# County of Santa Cruz

March 22, 2023

**Subject:** Public hearing to consider an appeal of Zoning Administrator's denial of Application 211316 for a proposal to construct an approximately 110-linear foot pin pier retaining wall, on-site with an existing single-family dwelling, located at 266 Cliff Court in Aptos.

C-1

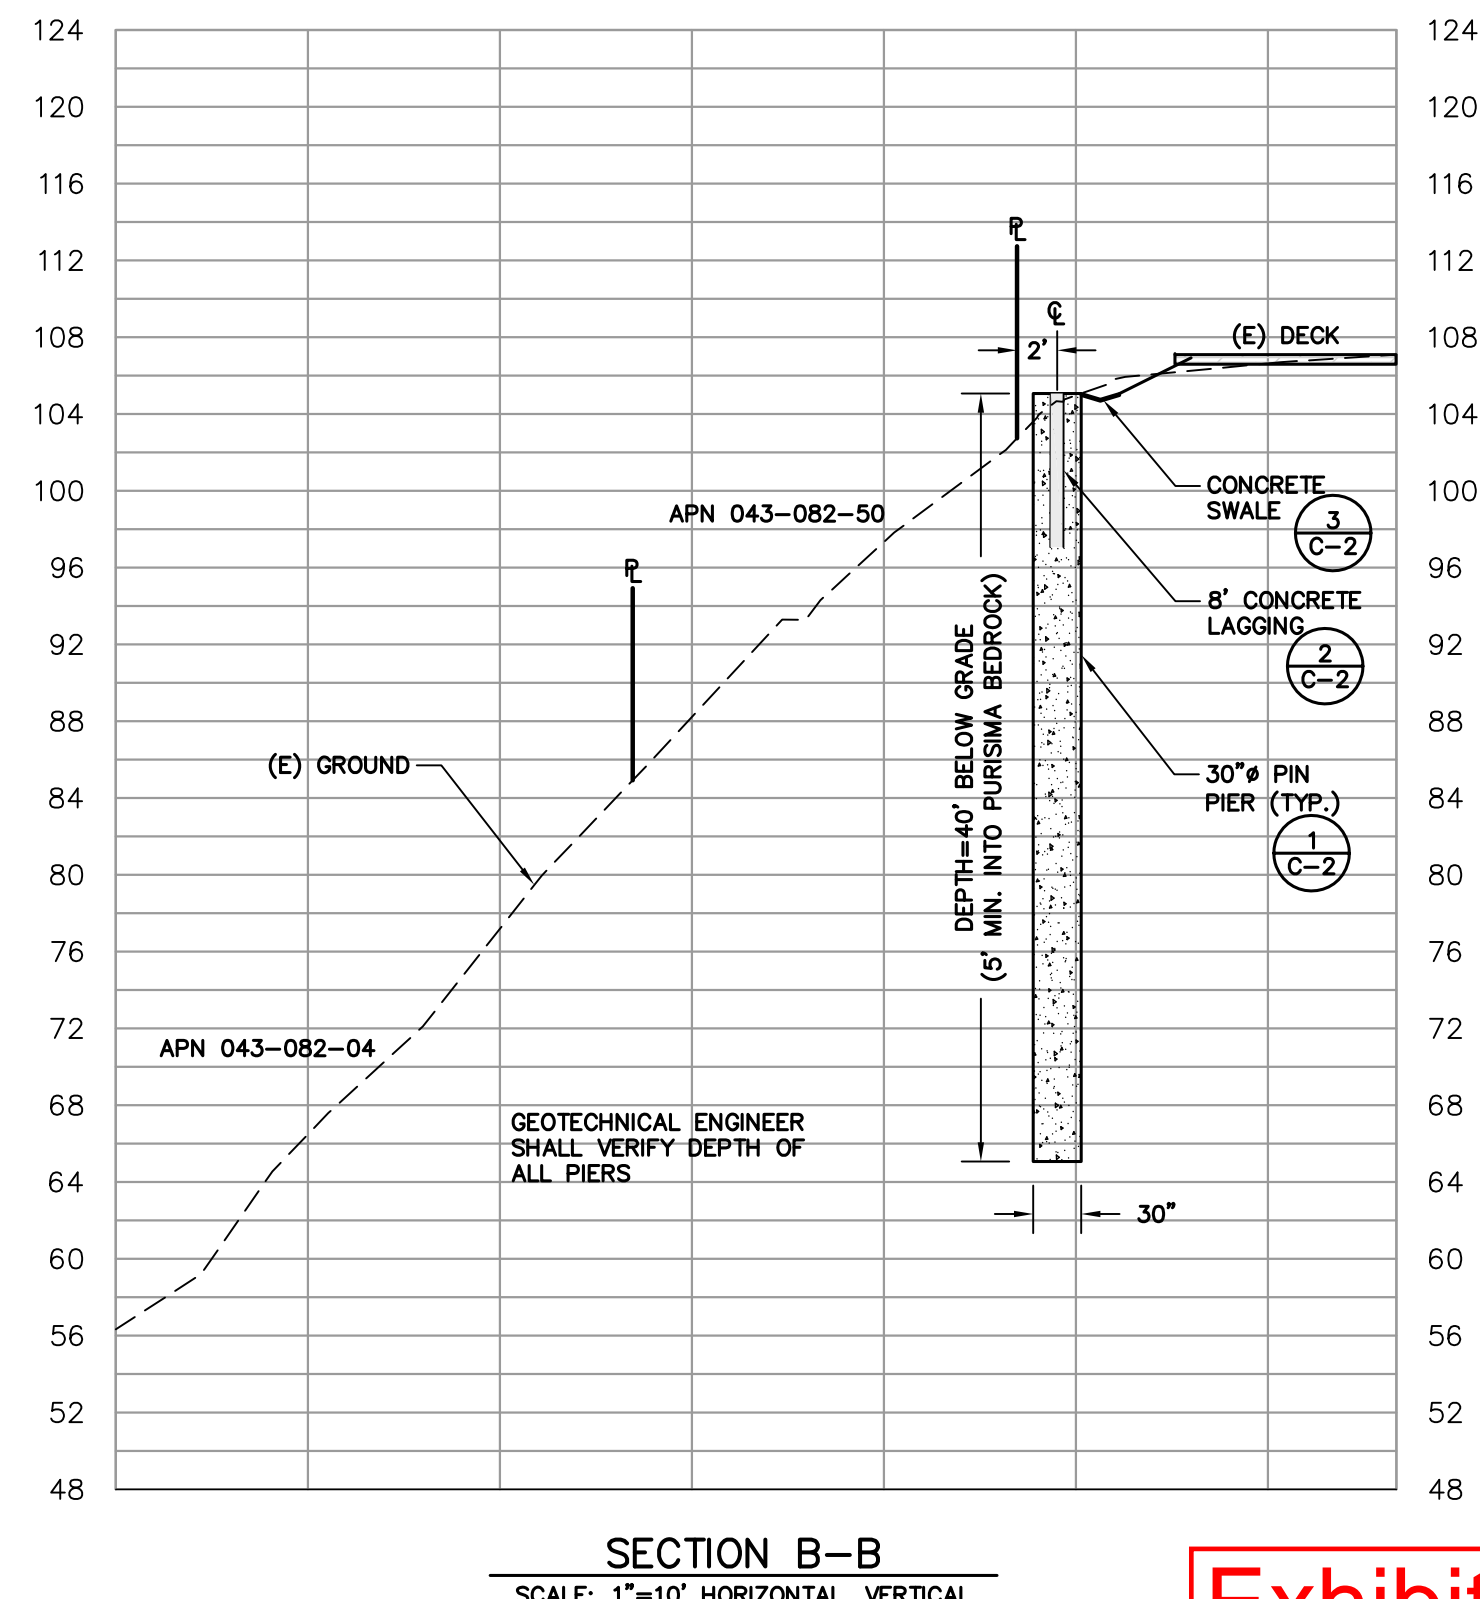
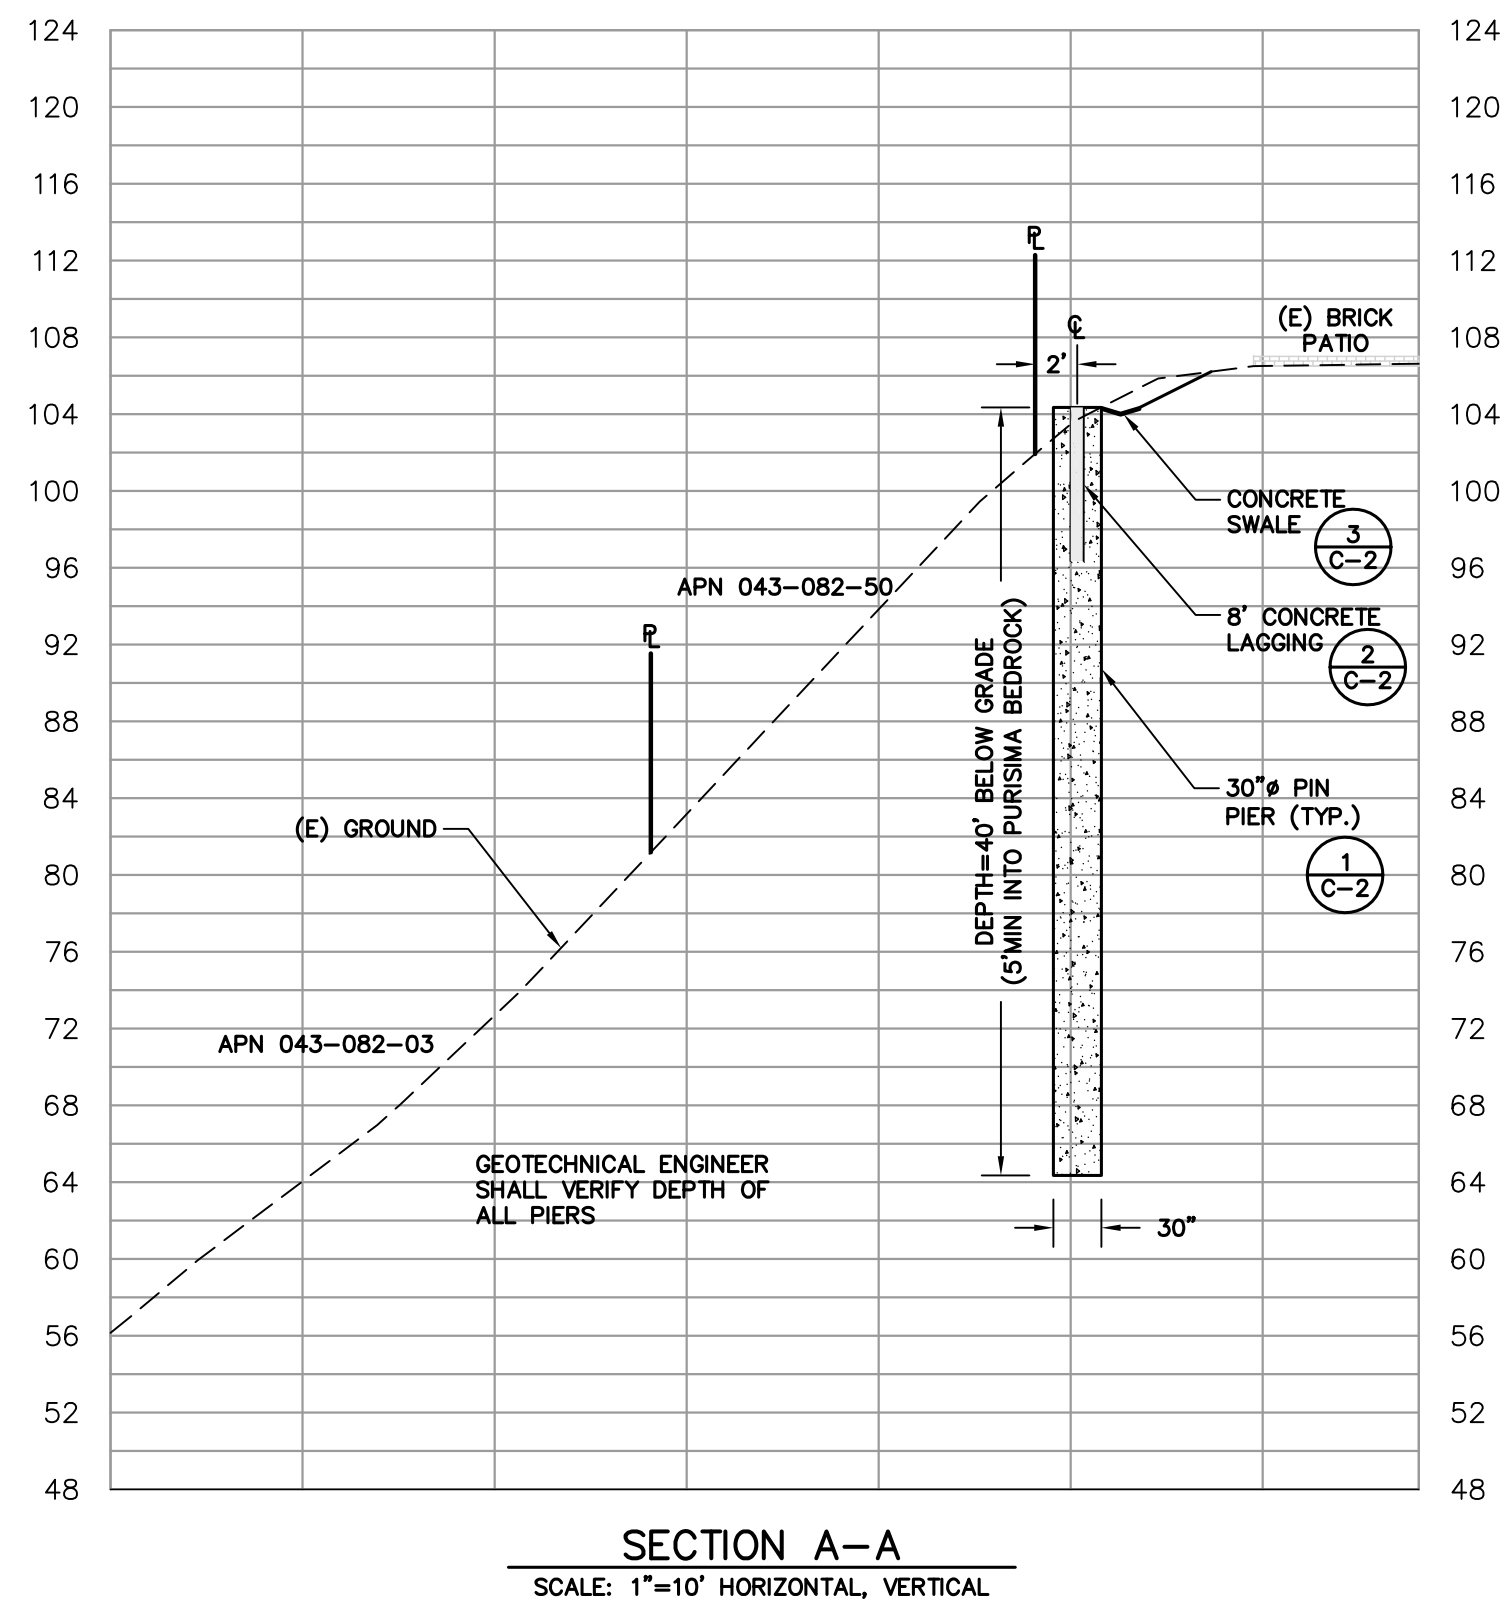
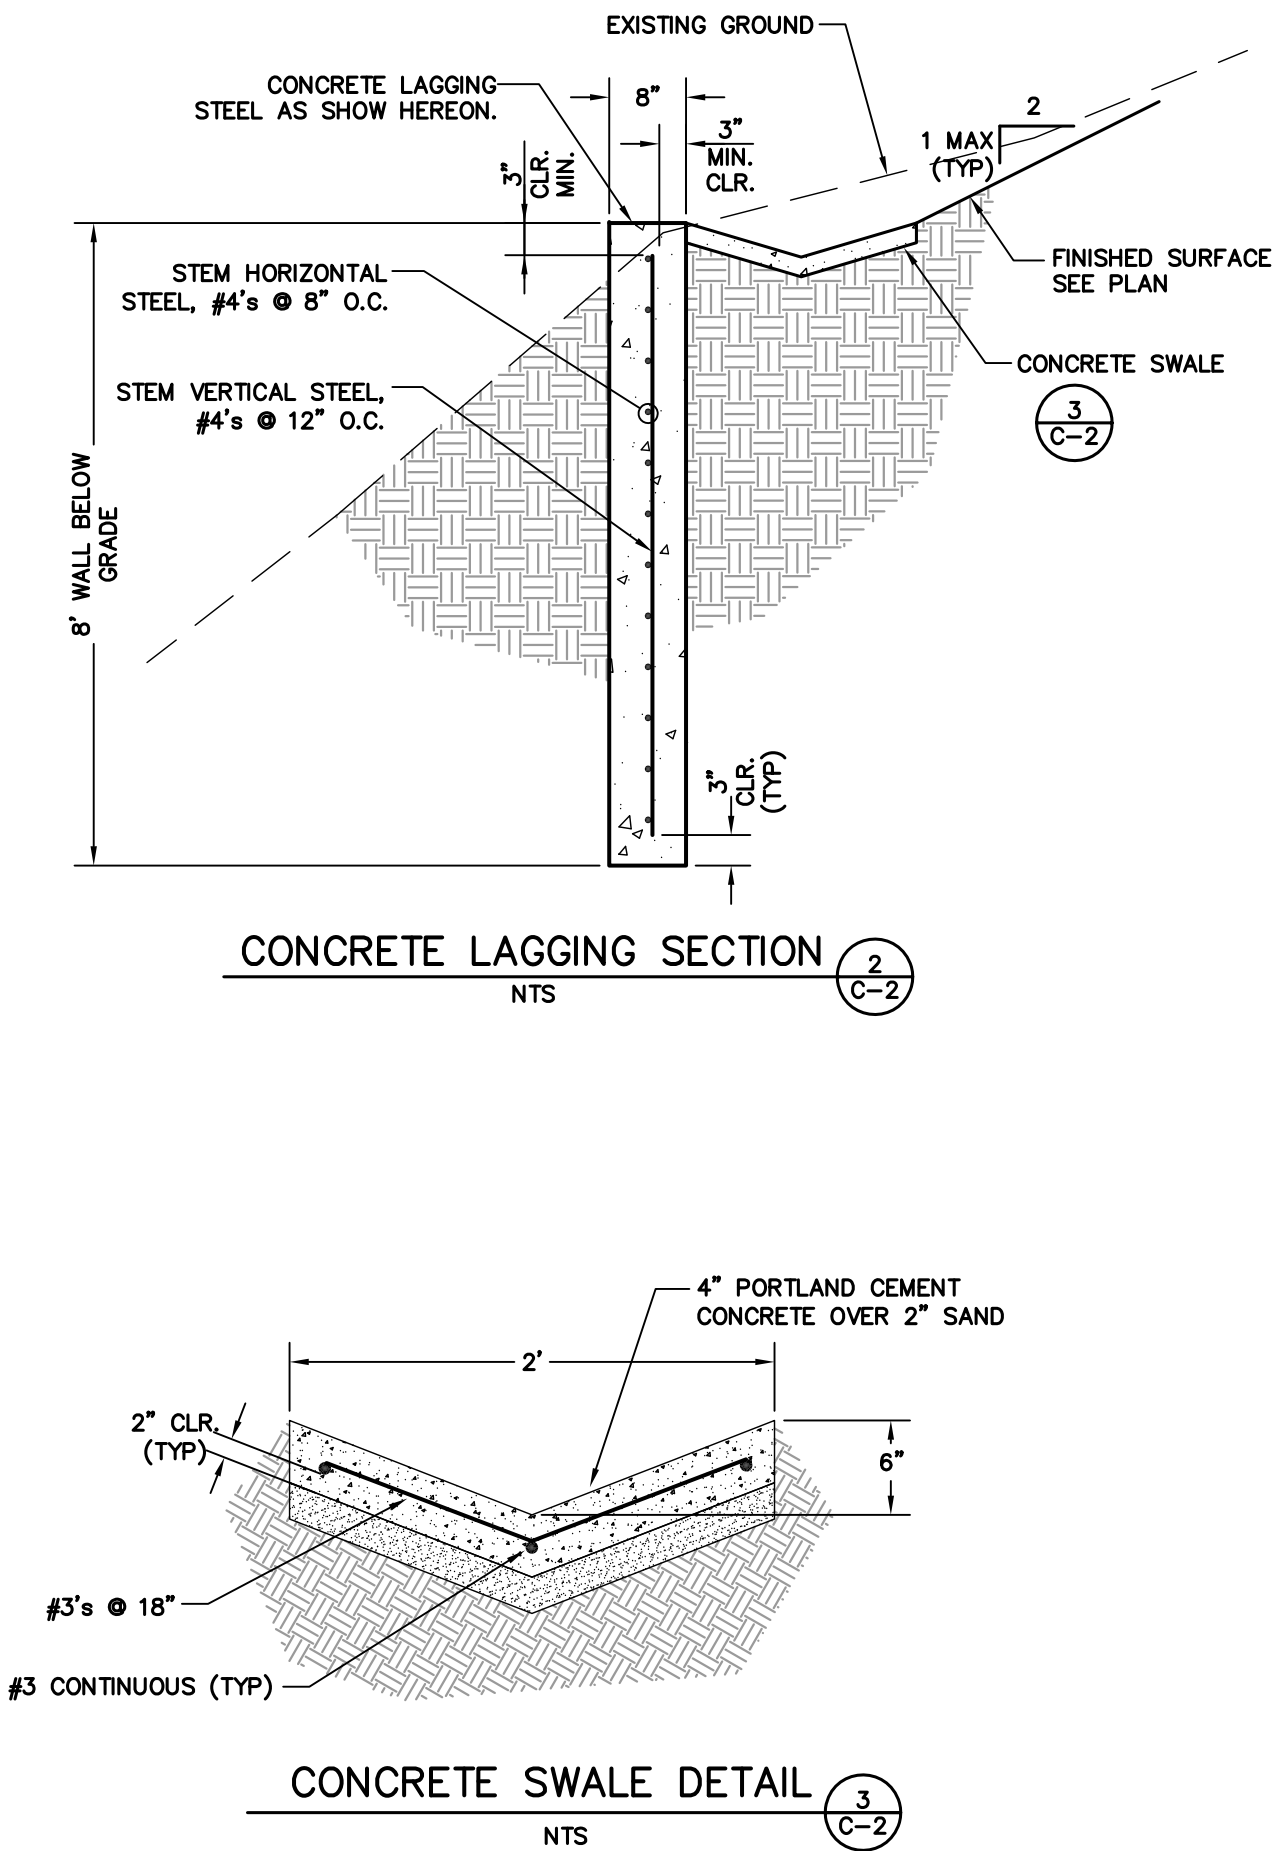
- Per Part 3 of the County Design Criteria, all development and redevelopment projects shall clearly show that proposed drainage patterns will not result in diversion of stormwater and will not adversely impact neighboring properties or drainage pathways.
  - The project design conflicts with Part 3 of the Santa Cruz County Design Criteria since diversion of stormwater is proposed and is therefore not in compliance. In order to bring the project into compliance with the County Design Criteria, the project needs to be changed so that it does not result in diversion of stormwater.
  - The County Design Criteria does allow for an exception to be considered for approval of diversion of stormwater. It states, “Diversion of runoff resulting in altered stormwater (drainage) patterns from the project site is not allowed without prior approval by the Director of Public Works.”

1. Provide topographic information that extends at least to the inlet on the property to the west that the proposed system will tie into. Provide detailed information about the diversion path (pathway, materials, slope, ownership, etc.) from the site to the point at which the path ties into the existing downstream path, or to the beach/ocean outfall, whichever is shorter.

2. Provide existing and proposed watershed area map/s. The existing map shall show the extent of on and offsite area/s that drain to the existing drainage facilities that will be removed as part of this project. The proposed watershed map shall show the extent of the on and offsite area/s that will drain to the proposed drainage system.

3. Provide a signed and stamped engineer’s analysis evaluating the adequacy of the condition, stability, and capacity (at least 25-year safe overflow is required) of the entire diversion path (see comment No. 2 above) – including private and public portions. Provide photo, video, and survey information used for the analysis. If any inadequacies are identified the applicant shall update the project scope to include upgrades/repairs/replacements

At the Zoning Administrator hearing, Mr. Machado accepted the proposed drainage plans with the following conditions:

1. Provide topographic information that extends at least to the inlet on the property to the west that the proposed system will tie into.
2. Applicant shall self-certify that the system has sufficient capacity for the proposed stormwater connection.
3. Applicant shall be required to certify in writing that they have sufficient legal rights to utilize the entire diversion path as proposed and shall further be required to execute a written agreement in a form acceptable to the County to defend, indemnify and hold harmless the County for all claims related to or arising out of applicant’s proposed use of the diversion path.”
4. Failure to comply with Conditions 1-4, as specified, will result in denial of the proposed diversion to a private system and the project shall be updated so that there is no diversion of stormwater.
5. No diversion onto Rio Del Mar Boulevard shall be allowed.
